EAGLE MOUNTAIN CITY
City Council Staff Report

Project: AUB Church
Applicant: Corp of the Presiding Elder of the Apostolic United Brethren
Request: Site Plan
Type of Action: Action Item

Project: Jiffy Lube Site Plan
Applicant: Elliot Smith
Request: Site Plan
Type of Action: Action Item

Project: Spring Run Church
Applicant: Corp of the Presiding Bishop Church of Jesus Christ of Latter Day Saints
Request: Site Plan
Type of Action: Action Item

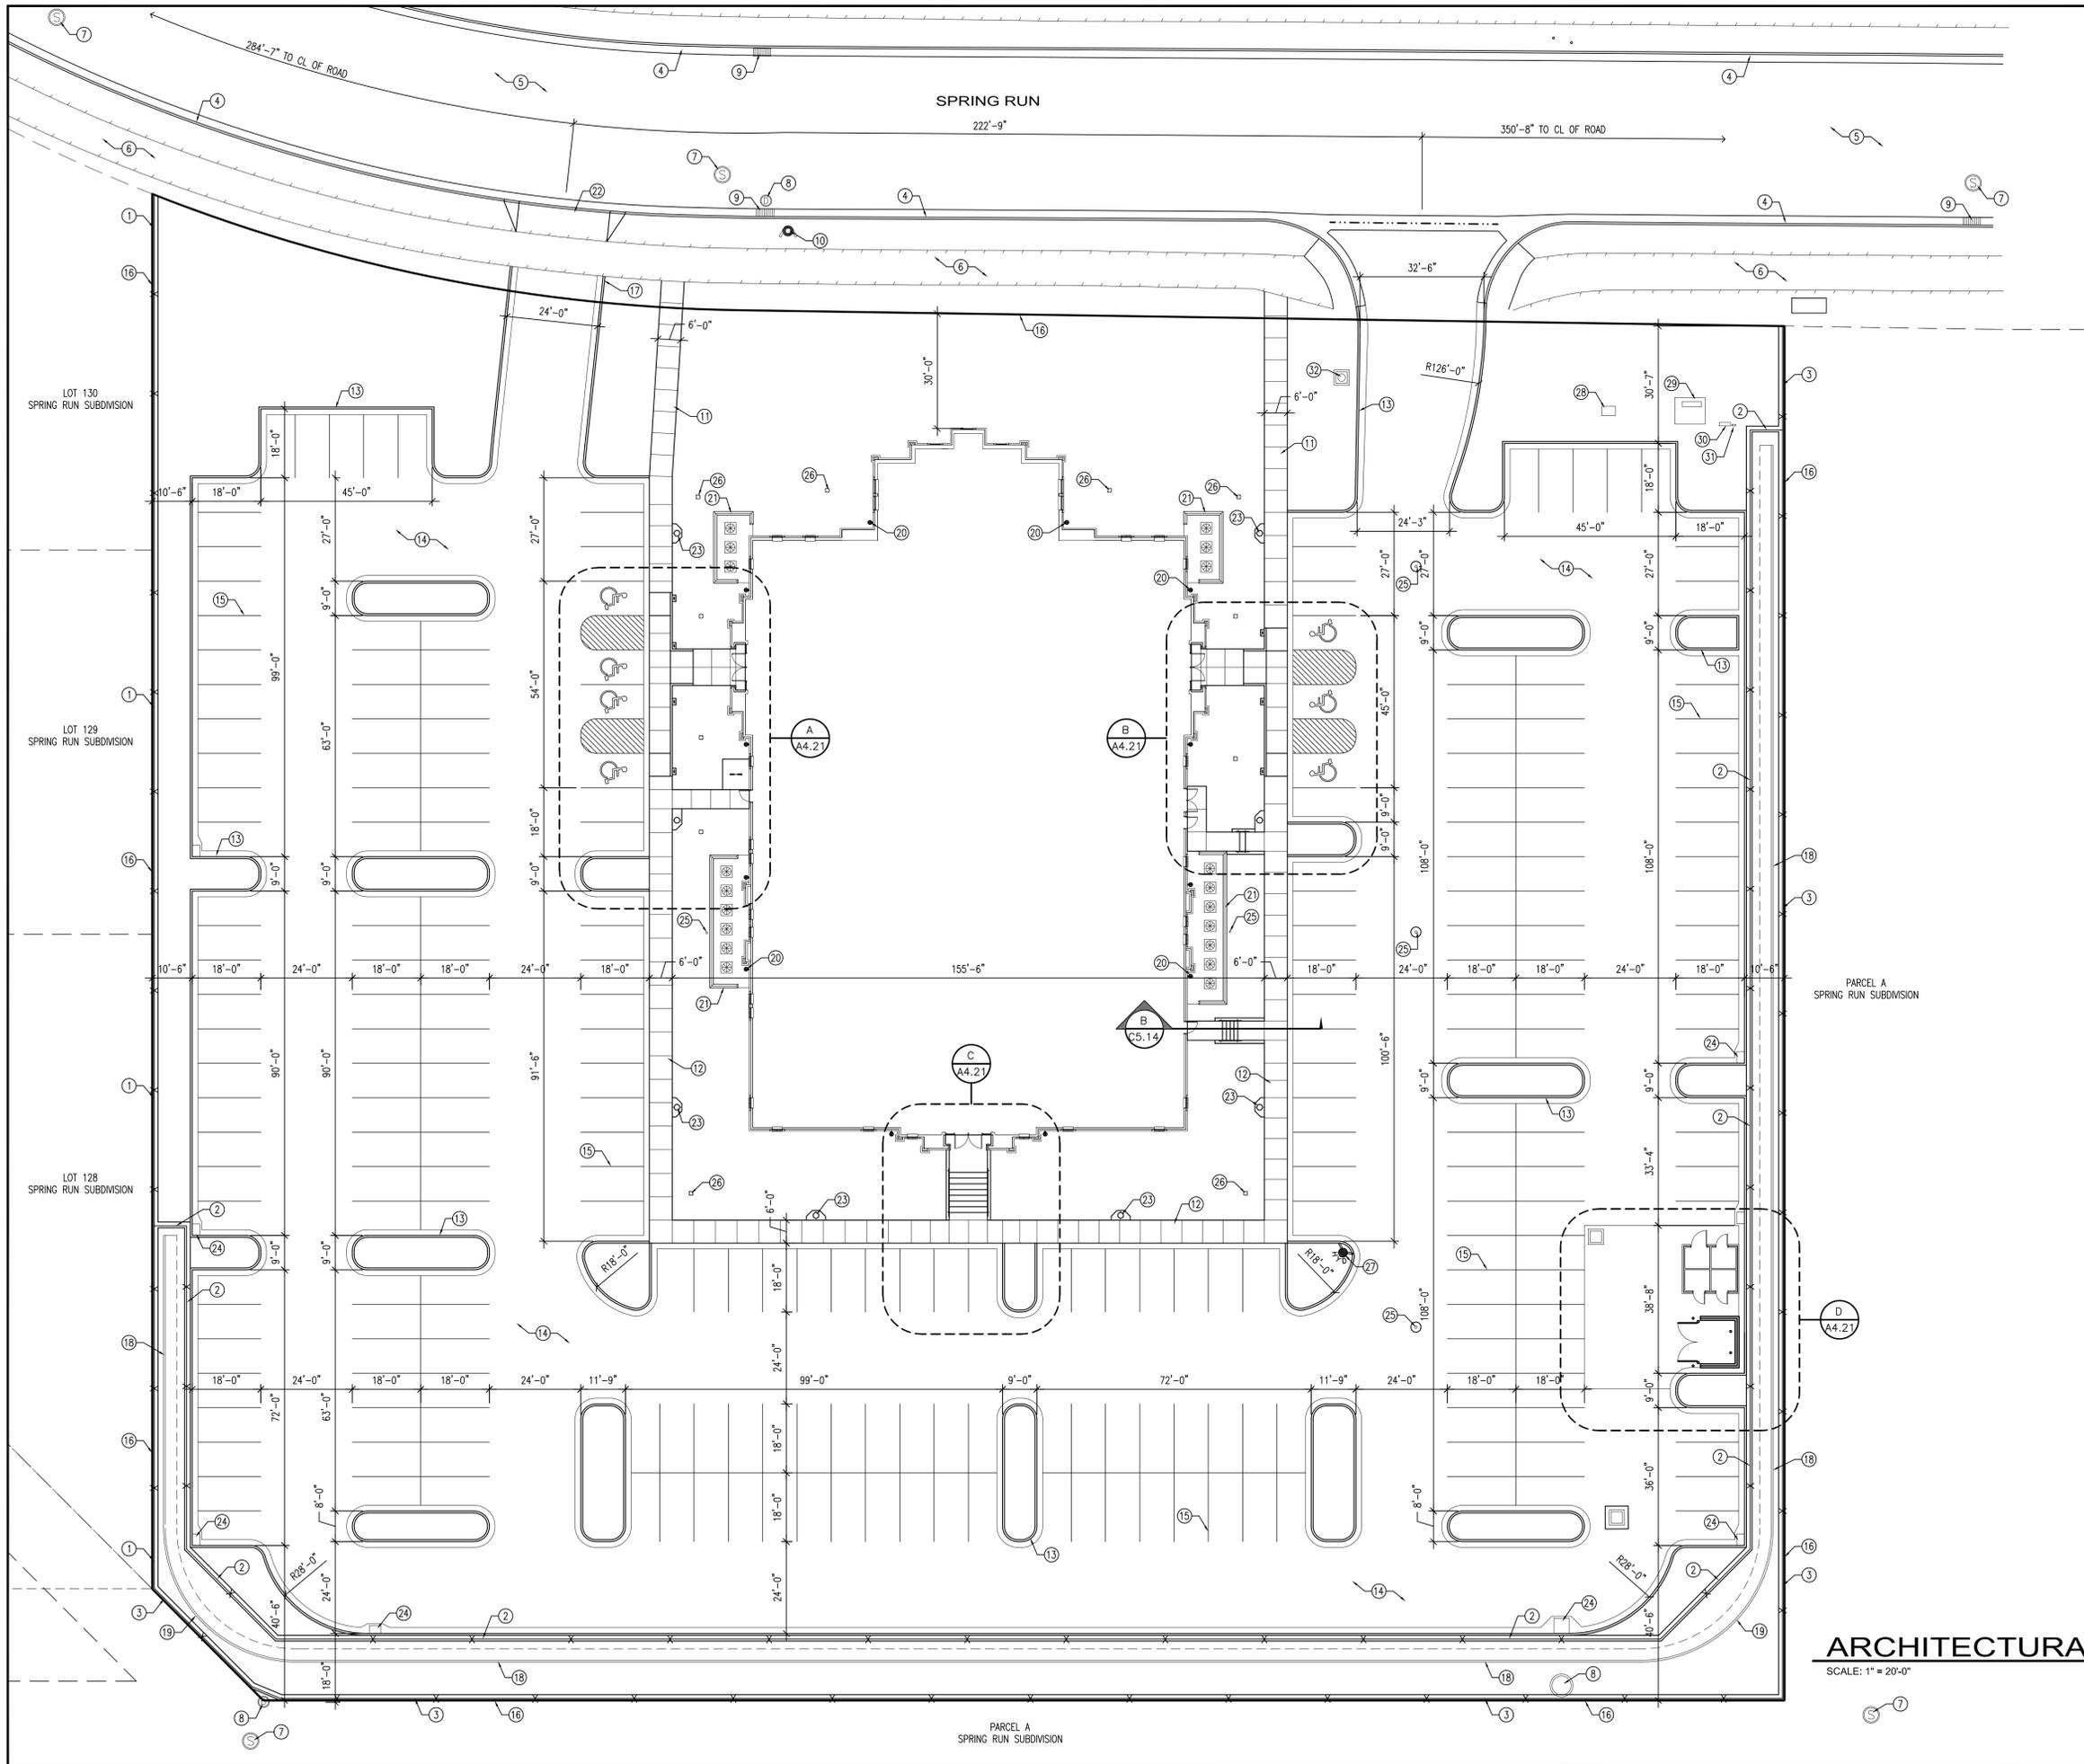
The Fire Marshall has reviewed the application and the following are required for approval: The addition of another fire hydrant (which the fire marshal has redlined on the plans) and providing an 8" fire line loop / 6" hydrant stub.

- 1. A Fire Hydrant and 8" Fire Loop Line / 6" hydrant stub be provided as per the Fire Marshal's review.*
